Provo School District

Construction Update

May 28, 2024

Proposed Changes for the Master Plan

1 – Site Utilities

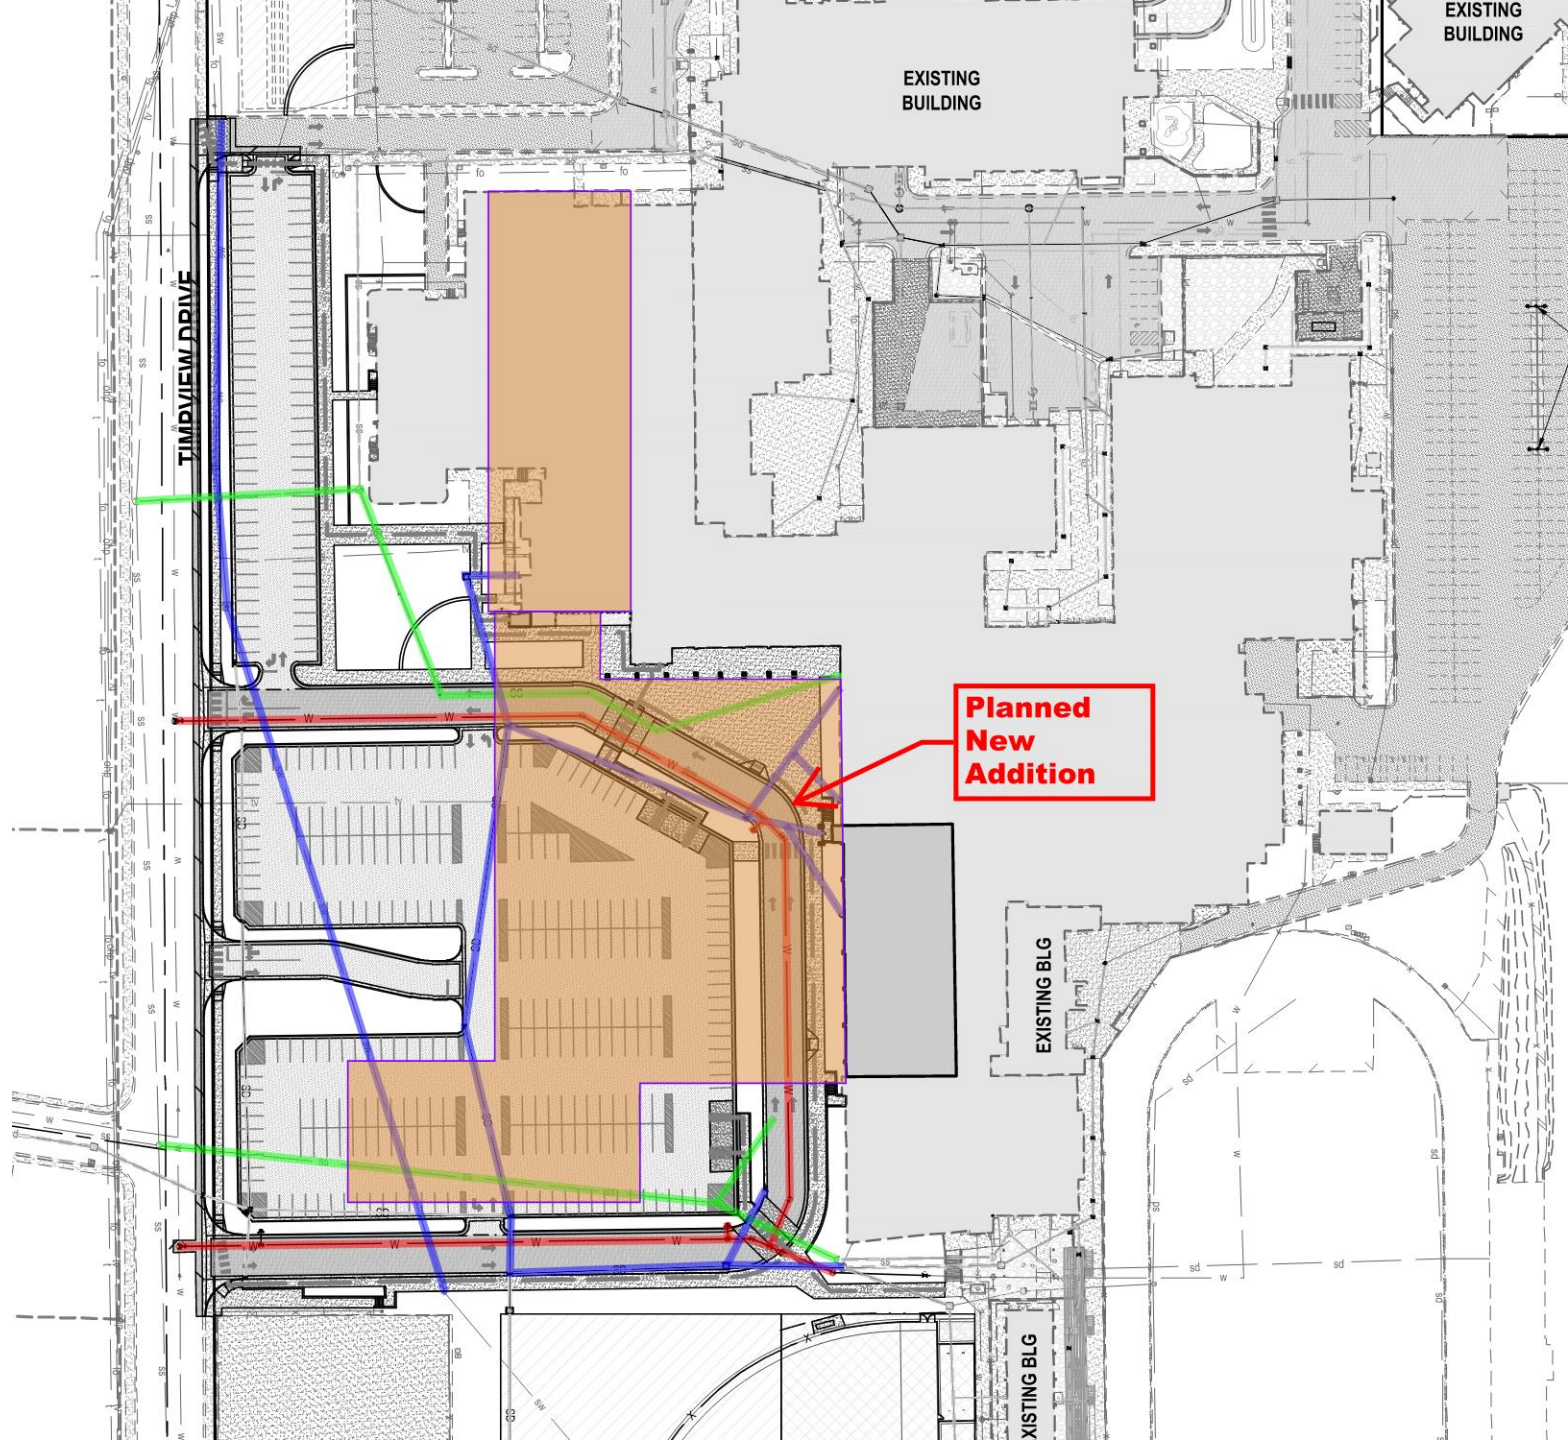
Locations of planned utility lines run under the proposed new addition. Due to current construction progress, not all utility lines will be able to be re-routed without causing delays.

- Provide shut-off valves for easy future connection and abandon lines not needed in the next phase.
- Relocate fire hydrants as allowed by the Fire Marshal.

2 – Site & Parking

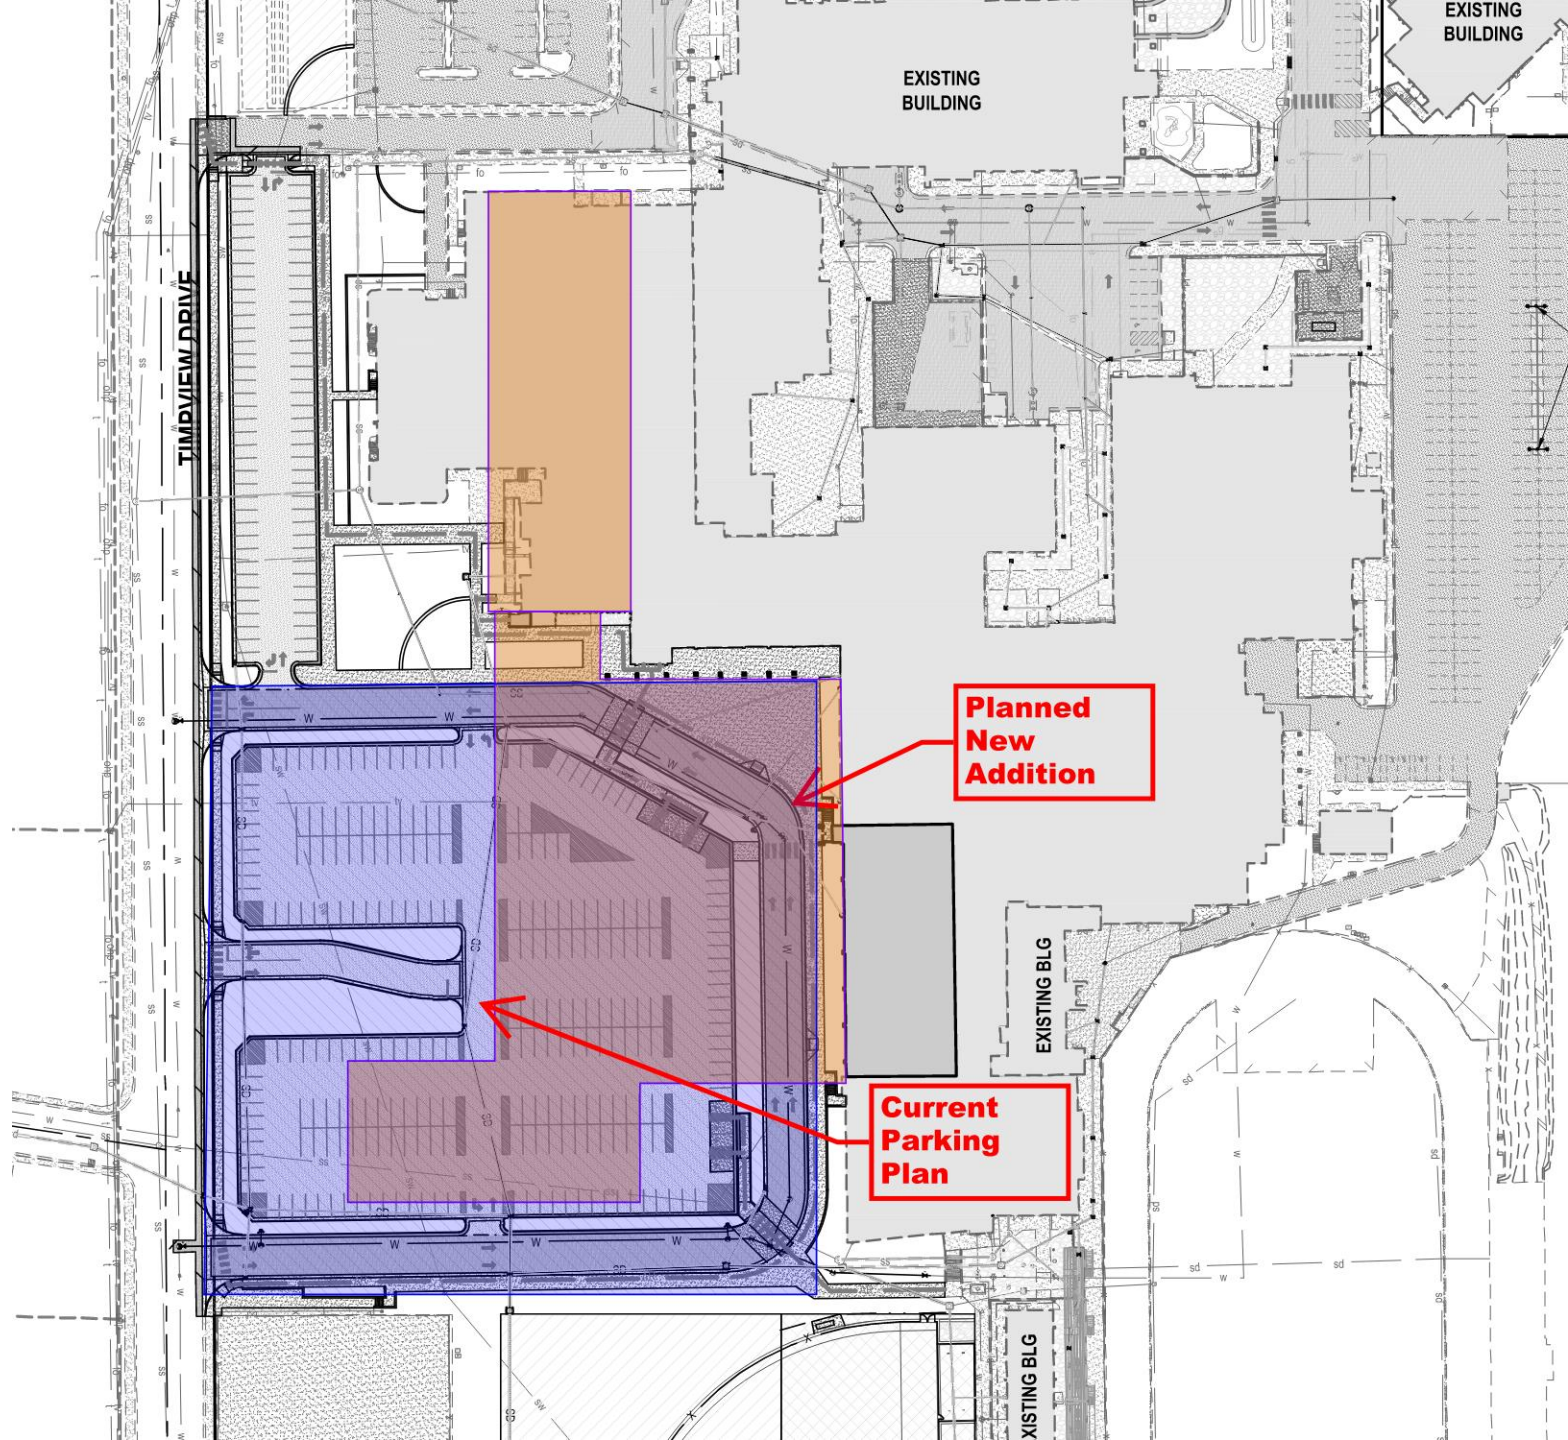
Current parking plan will not work with the new addition. However, ADA parking and circulation will still be needed until the new addition begins.

- Relocate site lighting to be outside of the footprint of the new addition.
- Re-design parking lot with minimal curb & gutter and landscaping.
- Provide only 2" of asphalt and minimize sub-base prep to reduce costs.

3 - Stairs

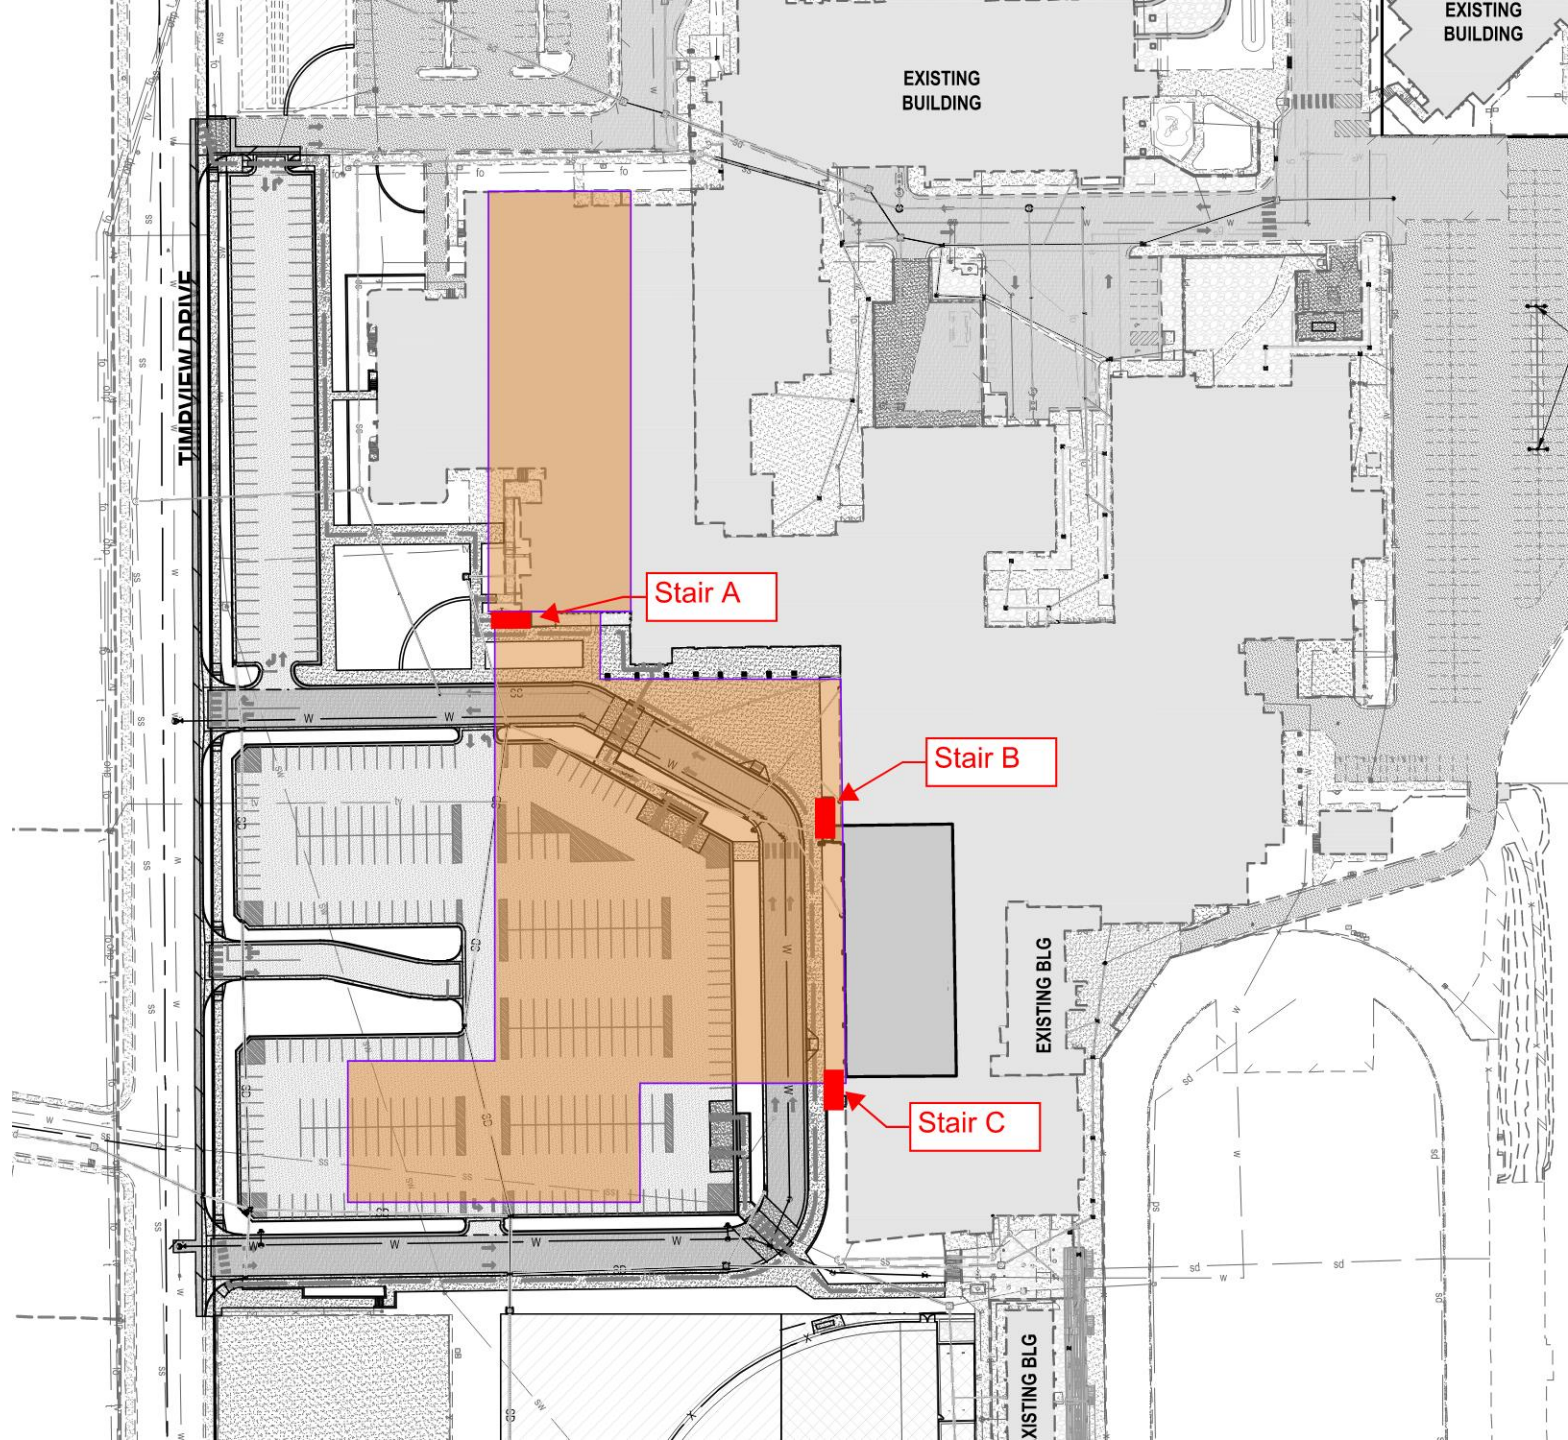
Stair A is required for egress from administration and currently planned to be enclosed.

Stairs B & C are exterior concrete stairs designed to provide direct access into the north & south gyms. Stairs B & C are not required for egress.

- Eliminate stair A enclosure and replace with an open concrete stair to provide egress (see next sheet).
- Eliminate stairs B & C completely.

4 - Entries

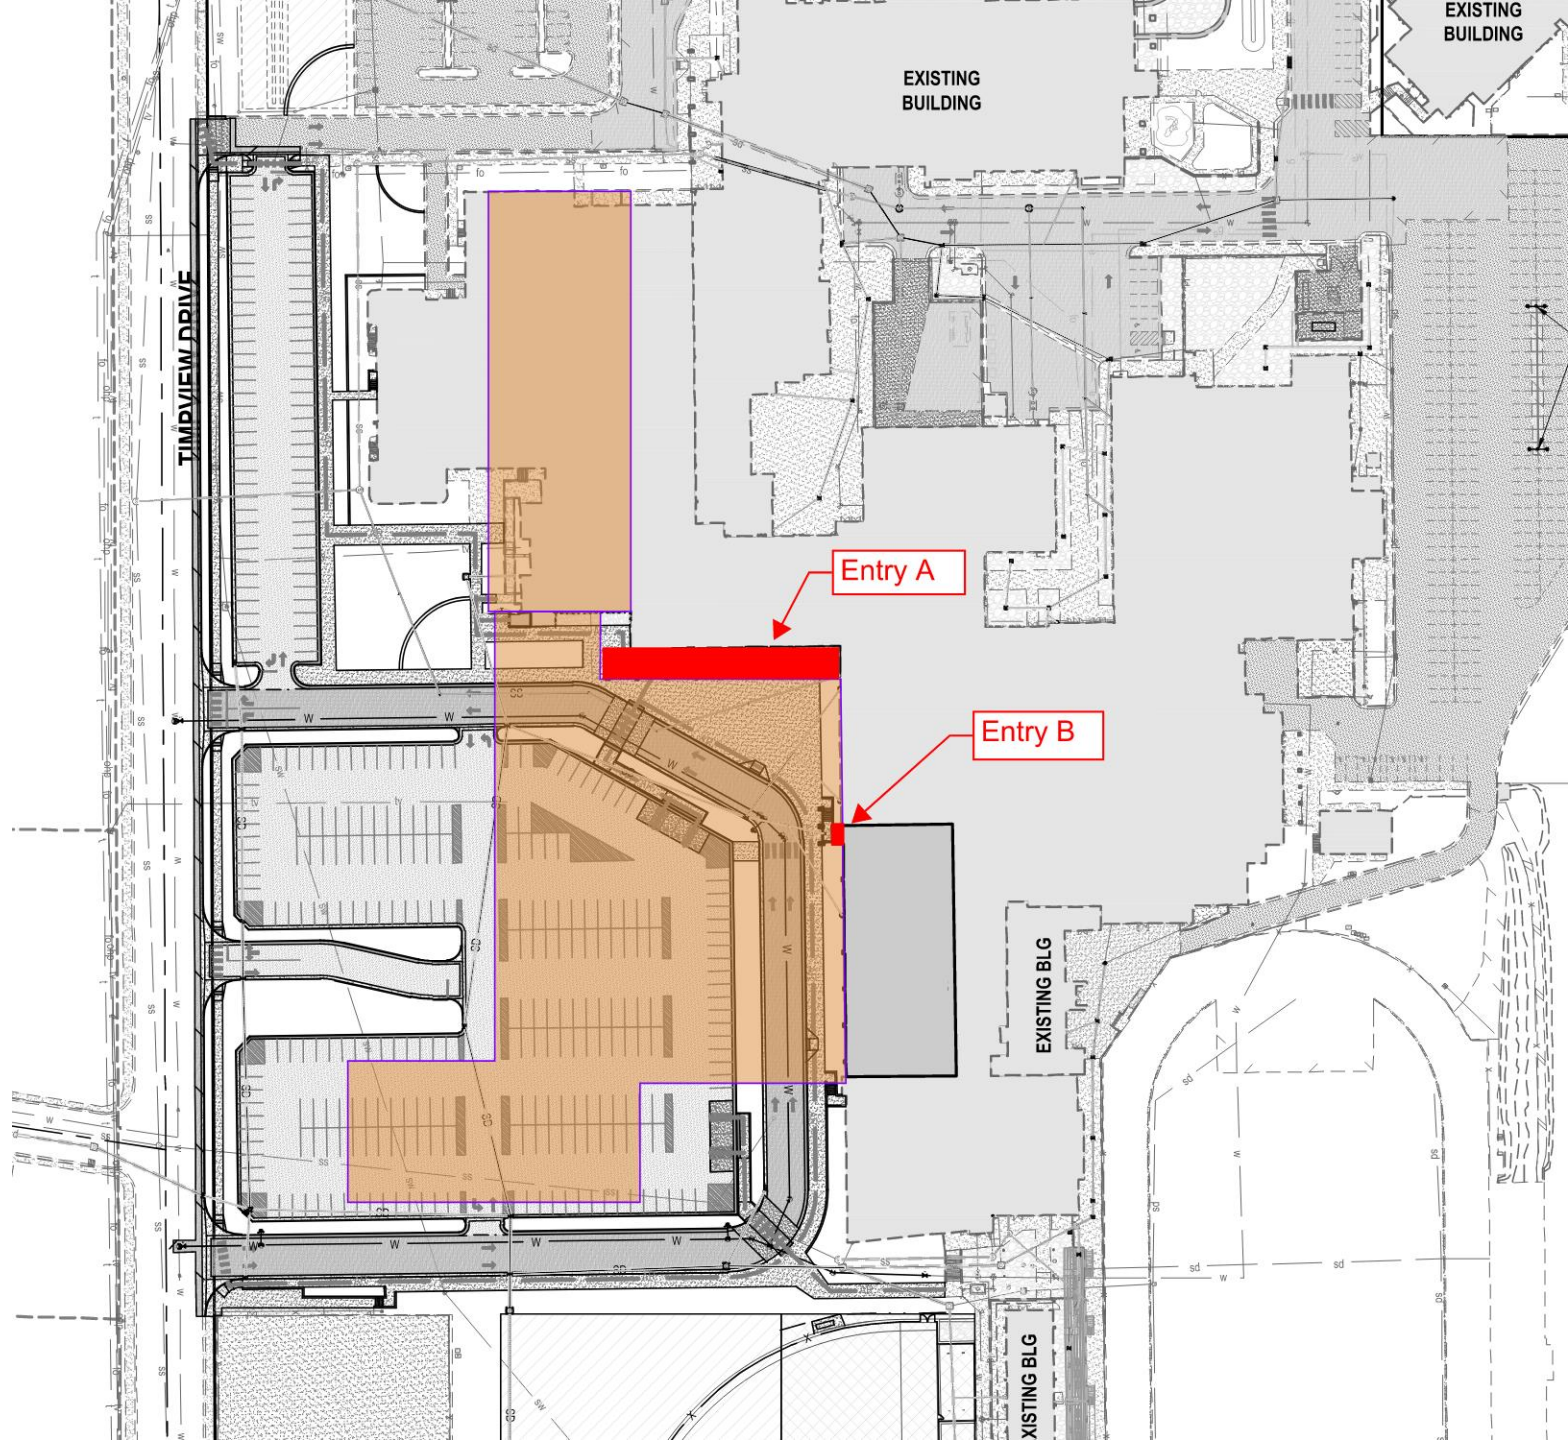
Entry A is the main entry into the secure vestibule between Administration and the Commons.

Entry B was design to provide direct access to the north gym from the front parking lot.

- Reduce the size and scope of the canopy at Entry A (see following sheets).
- Eliminate Entry B including the canopy and vestibule (see following sheets).
